Swansgate HOA
2808 Churchill Ct
Highpoint, NC 27262

An inspection of the stormwater ponds were completed on 9/13/24, and the findings indicate that the all the ponds, while currently functioning, are in need of some maintenance work to ensure they stay in working order. This particular community is in a difficult situation to manage as the ponds are on private property but the HOA still has an obligation to maintain the stormwater ponds. The stormwater regulations in NC were not as detailed when these ponds were likely constructed and they have likely been “grandfathered” in. They don’t necessarily fall under the same scrutiny as new construction. However, municipalities are aware of this and have begun going back to older systems and requiring several updates for functionality.

SG2

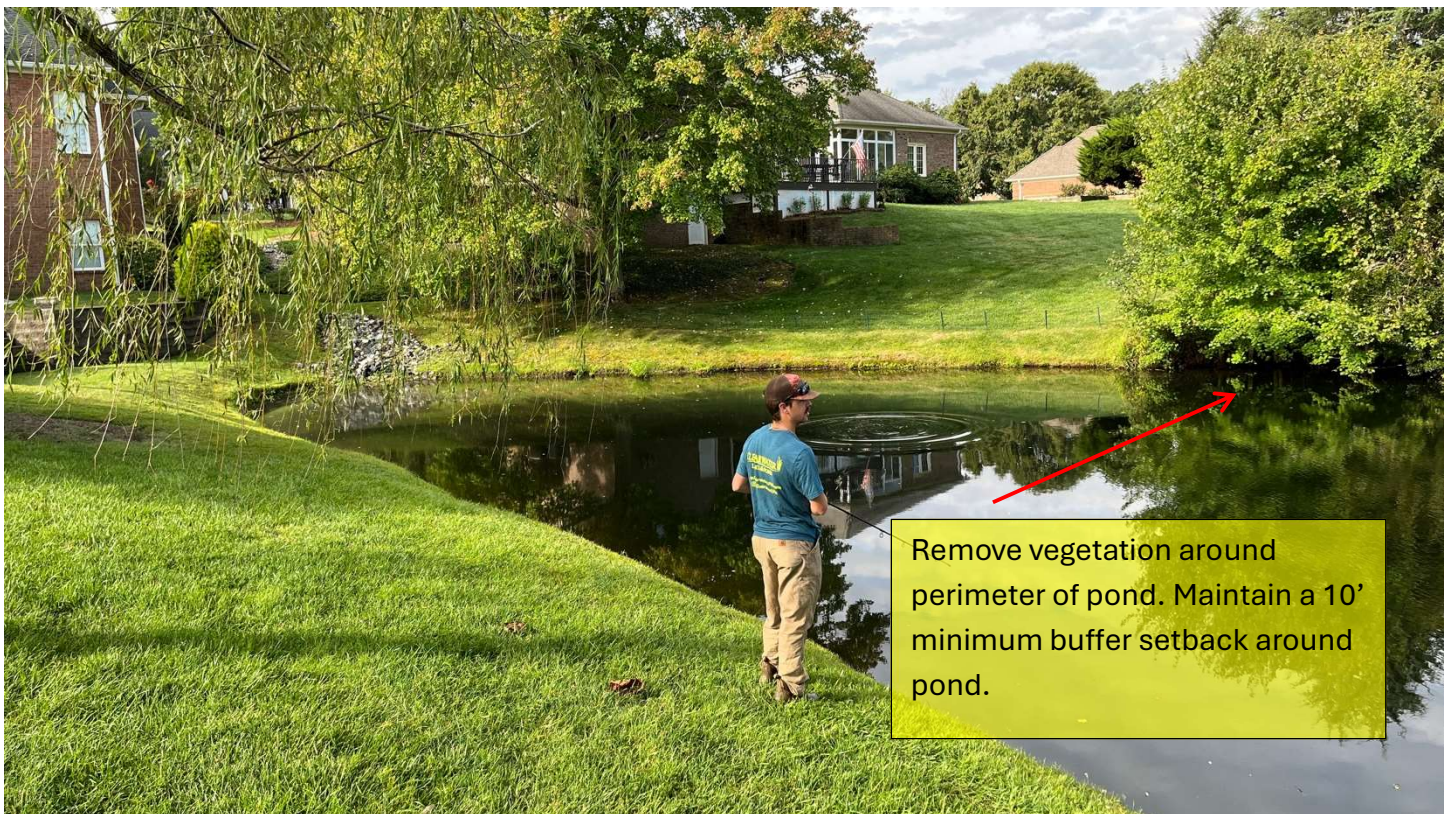
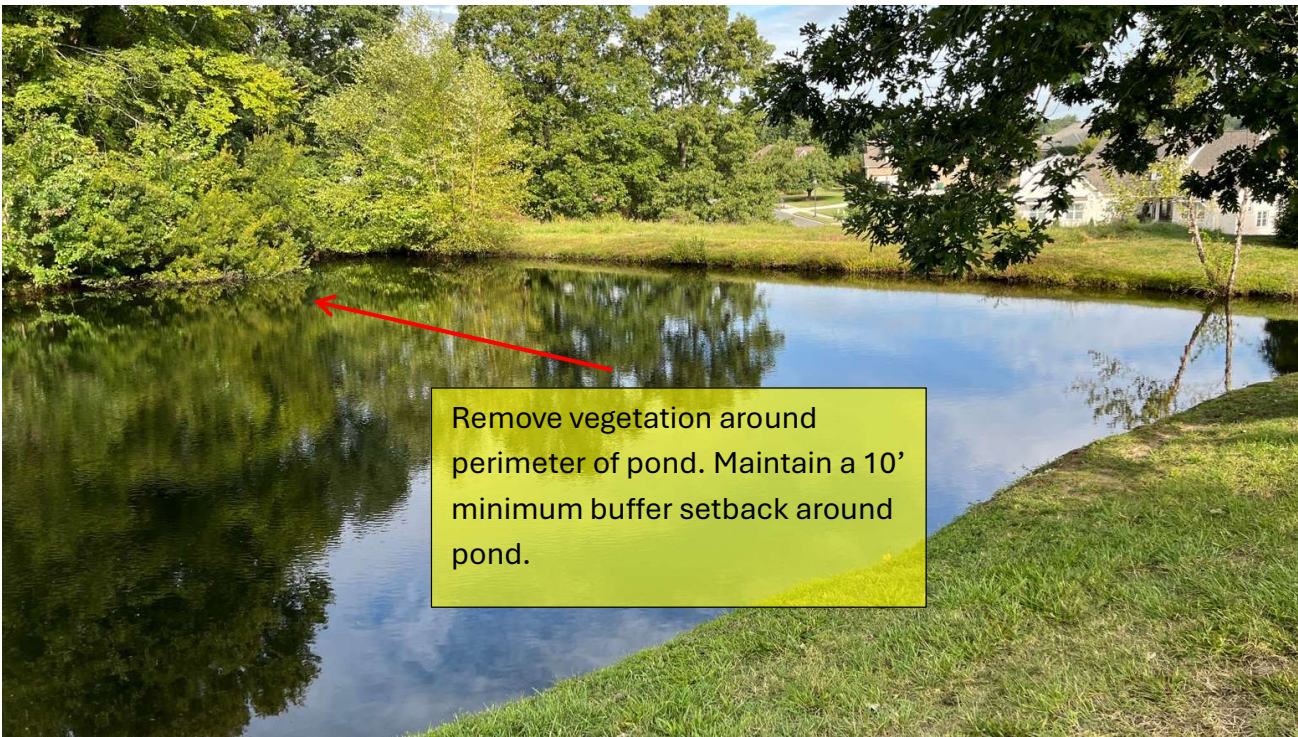
Suggest removing any woody-stem vegetation along dam.

Inlet swale needs reshaped and additional riprap stone placed to slow water velocity down prior to entering pond.

Weed growth in current riprap indicates sediment build up over time.

Preliminary Estimate: \$4,000 – Reshape inlet and redo dissipator pad with riprap and separation fabric. Includes minor brush removal around pond banks (not much noted within buffer zone).
